Re: Petition No. 1387  
Bloom Energy Corporation  
160 Old Amston Road, Colchester, CT  
Interrogatories  
BE Project No. EVS000.A

**Our response is indicated in bold type following each interrogatory contained in the Interrogatory Letter dated November 19, 2019.**

DETAILED SITE PLAN

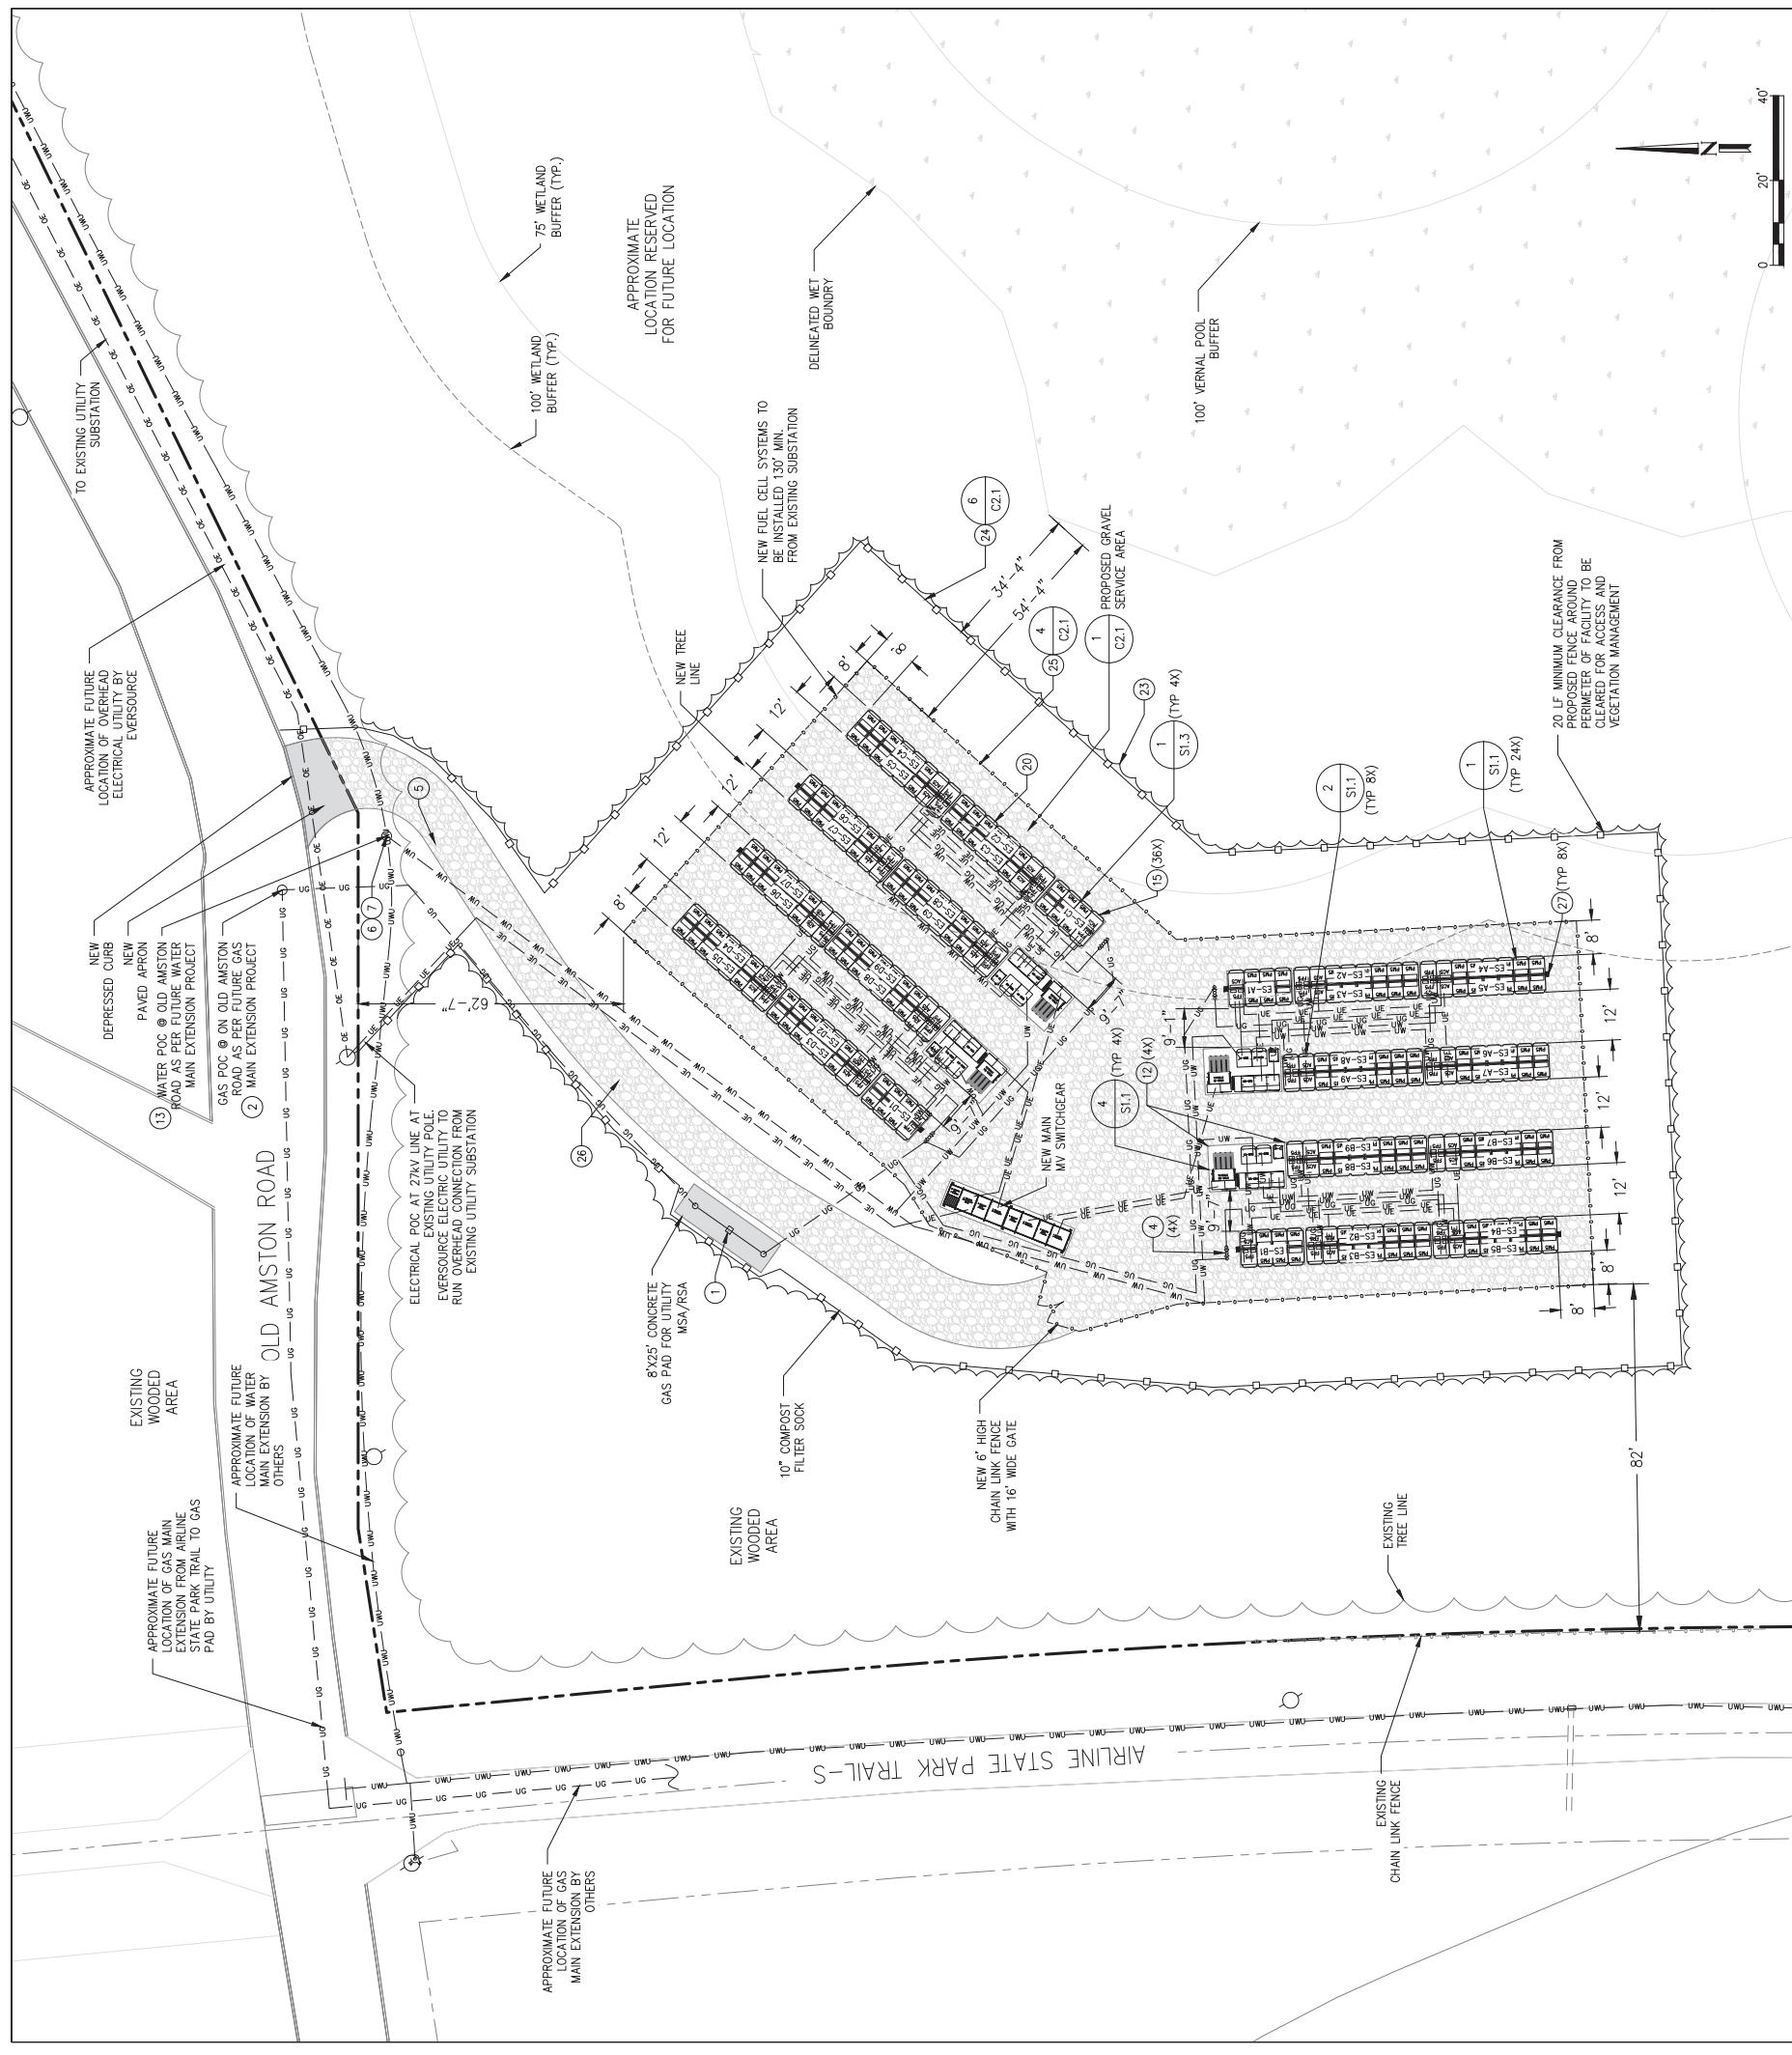
4. Referencing Drawing No. C1.1 under Exhibit 2 of the Petition, what is the 8-foot by 25-foot concrete gas pad to be used for? If it is to be used for natural gas equipment, why are no natural gas lines depicted as connecting to the concrete pad area?

6. Referencing Drawing No. C1.1 under Exhibit 2 of the Petition, Reference Sheet Notes No. 26 states, "Proposed paved site access entrance with parking area for service vehicles." There does not appear to be a No. 26 depicted on this drawing. Would the only paved surface for this project be the "New Paved Apron" off of Old Amston Road?

19. What is the host municipality's setback regulation from wetlands? Drawing No. C1.1 shows a 100-foot wetland buffer. The eastern portion of the project footprint is located within this 100- foot buffer. Please revise Drawing No. C1.1 to reflect the municipal wetland buffer.

**This was an error on the original submission. Sheet C1.1 has been revised to show the correct natural gas routing at the facility (see Amended Exhibit 2).**

**The note on the plan has been revised. Note #26 is now referenced on the drawing, denoting the proposed gravel access drive to the facility. The only paved surface for this project is the 'new paved apron' off of Old Amston Road, which does not have an associated reference note attached to it (see Amended Exhibit 2).**

**The Town of Colchester Conservation Commission regulates a 75-foot Upland Review Area to wetlands and 100-foot Upland Review Area to the ordinary high-water mark to watercourses. Drawing No. C1.1 has been revised to show the municipal 75-foot Upland Review Area to the delineated wetland boundary.**
